updated 05/08/2018

iHome		GAW	
Title: Google Voice Assistant Enabled Wifi/Bluetooth Speaker			
Version: 7		Model #: iGV1	
Designer: MB Poandl			
Date: 5.09.18			
CONFIDENTIAL and PROPRIETARY: The information contained herein including, but not limited to the products, renderings, concepts and designs comprise intellectual property of SDI Technologies Inc. and shall be kept confidential and shall not be used or disclosed by the recipient without the written authority of SDI Technologies Inc.

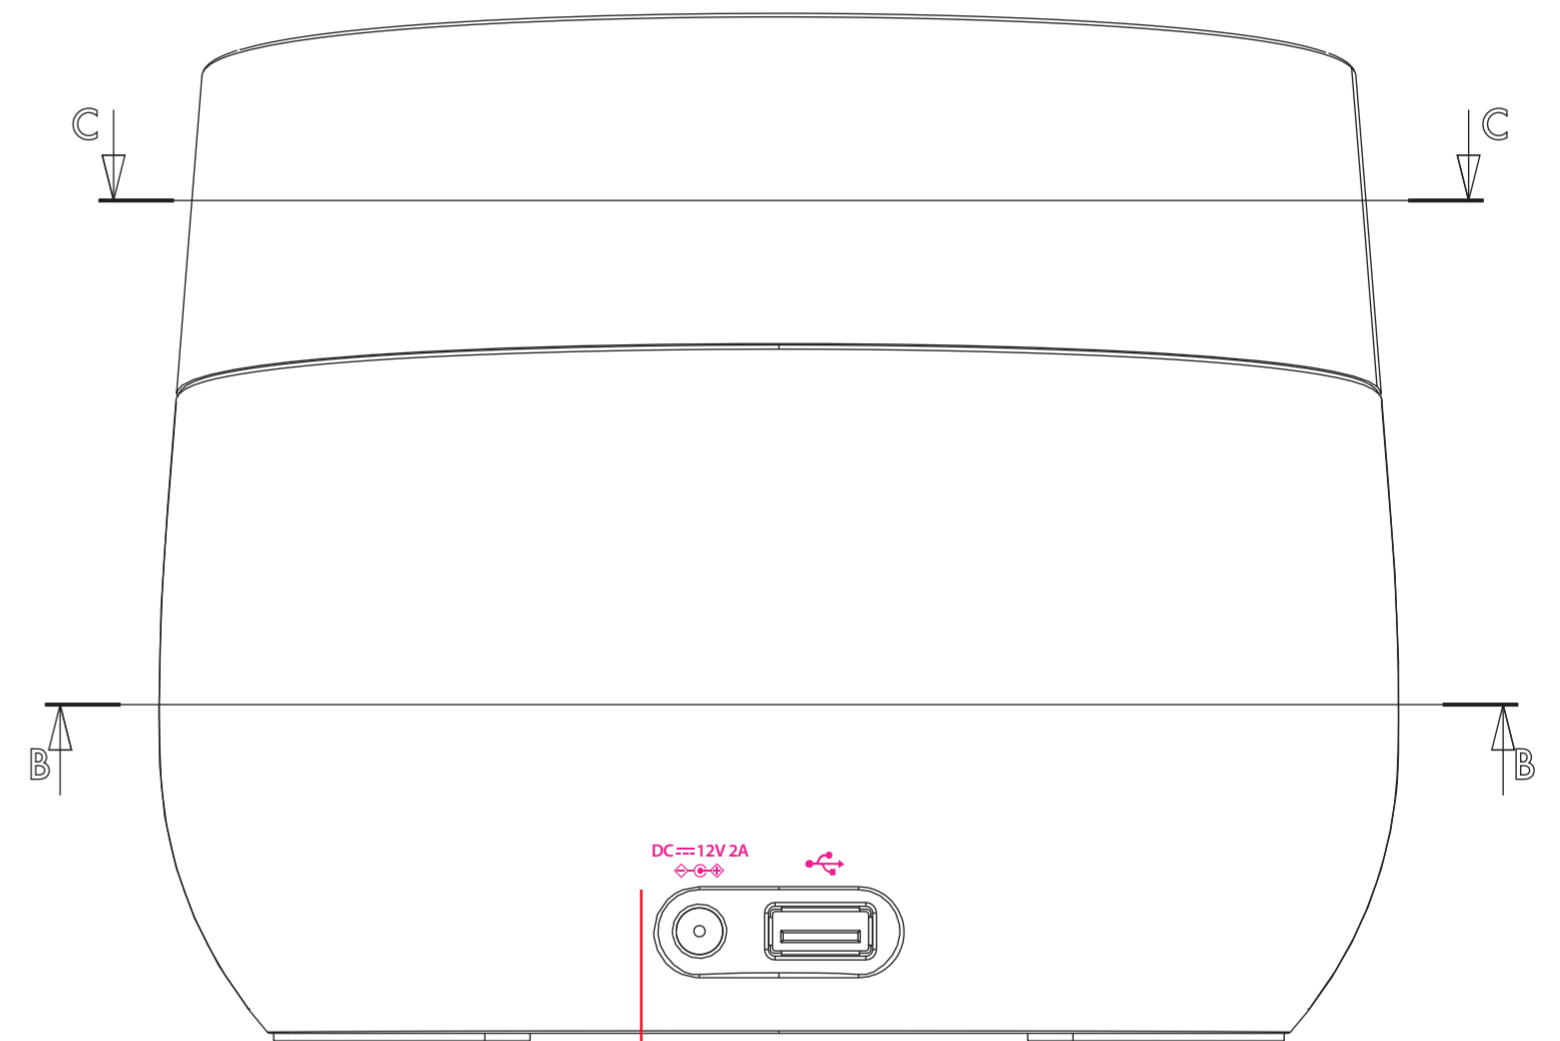
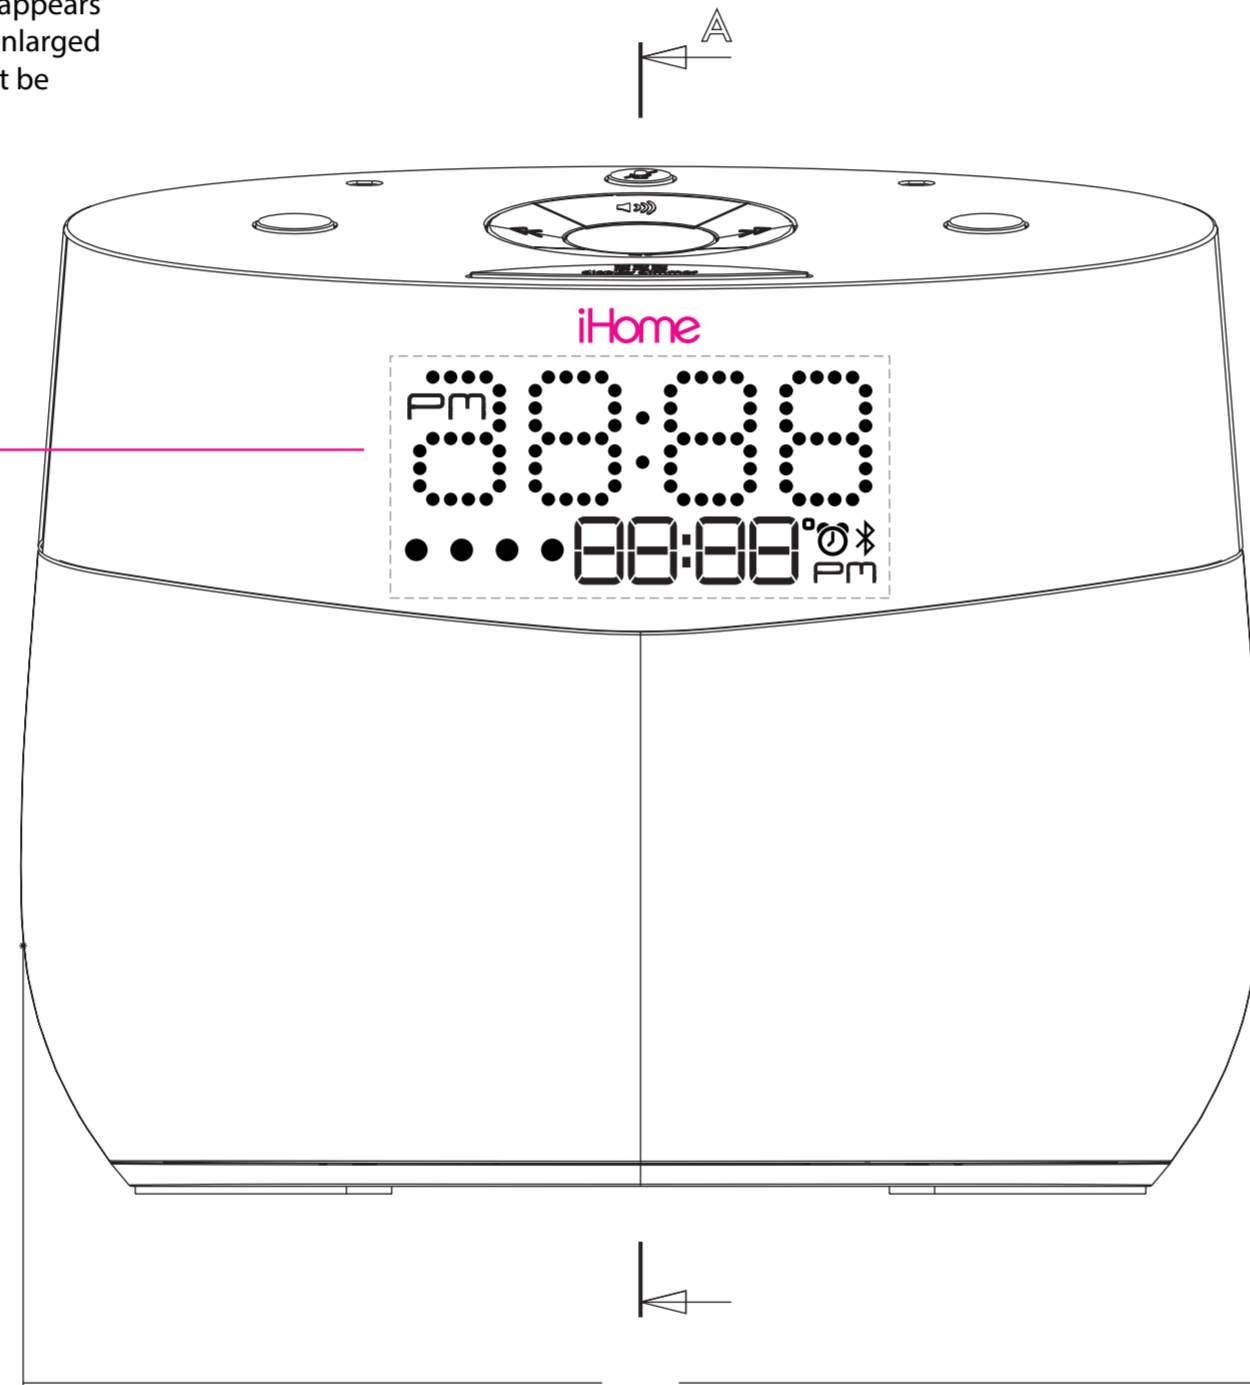
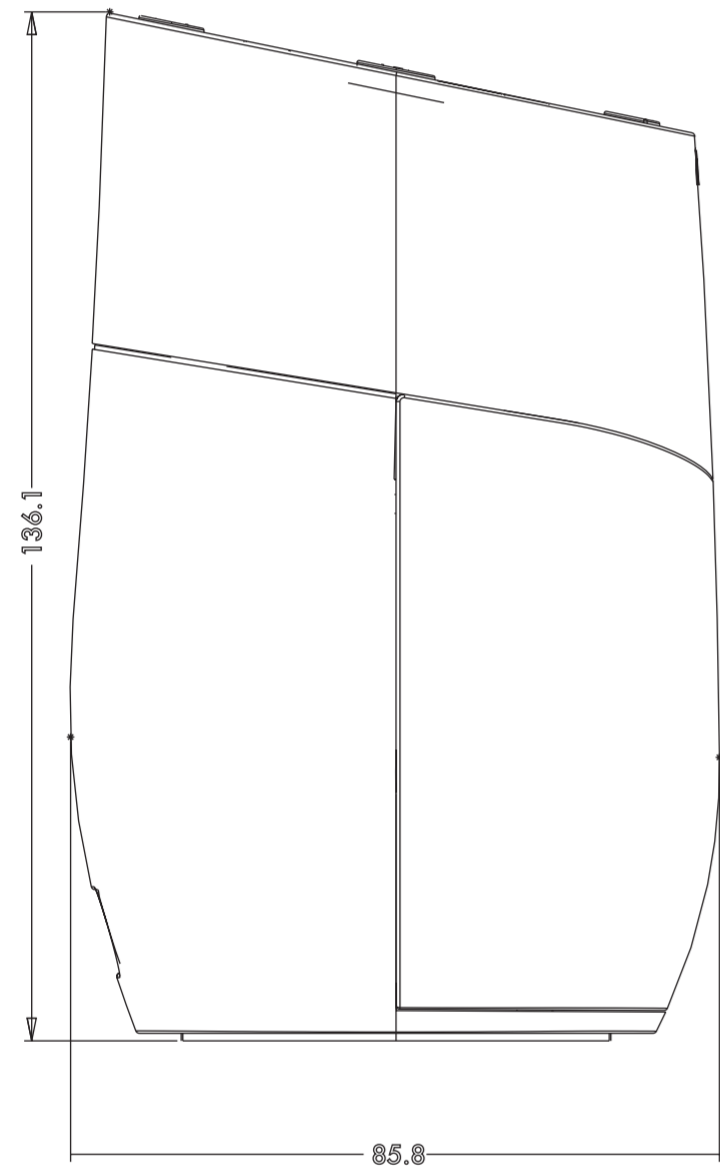
microphone button no longer backlit, becomes silkprint Google assistant colors. Bluetooth button and play/pause swap positions.

moved snooze bar in per maker recommendation, buttons are laser cut & backlit

Dotted line does not show. Display is white LED with curved front. LED display appears behind plastic. Google indicators, enlarged to 3mm, embedded in display-must be RGBW. Temp icon added

display for DMU

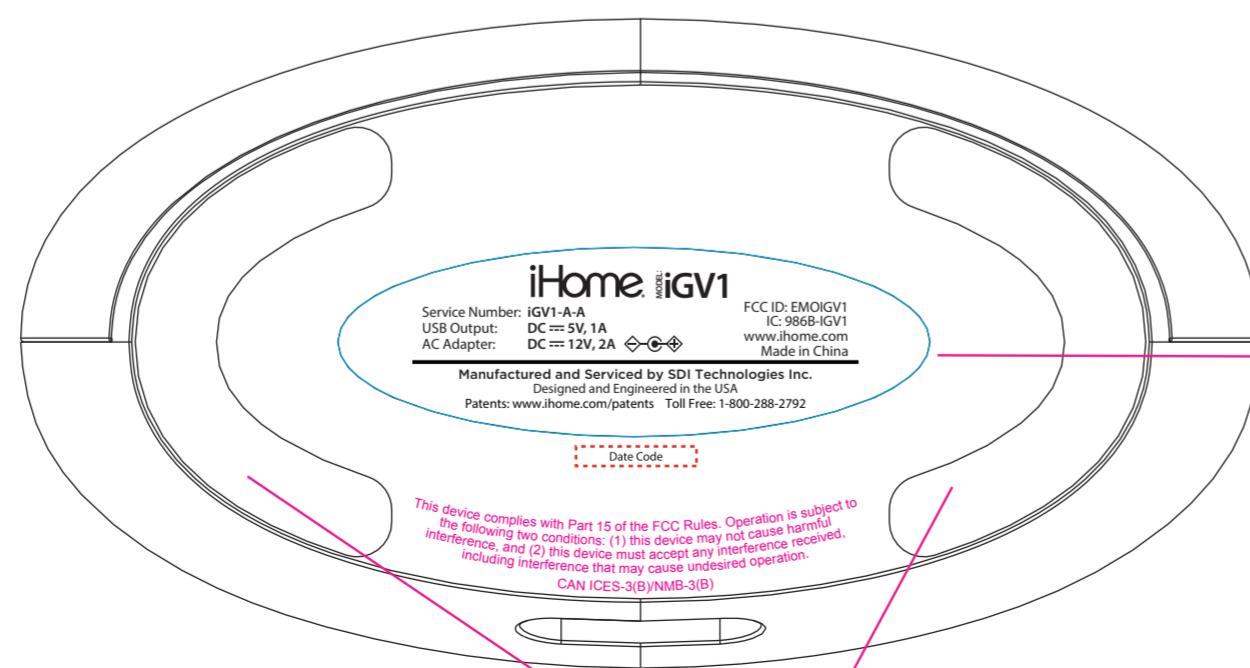
2 smaller rubber pads with adhesive as spec'd by maker
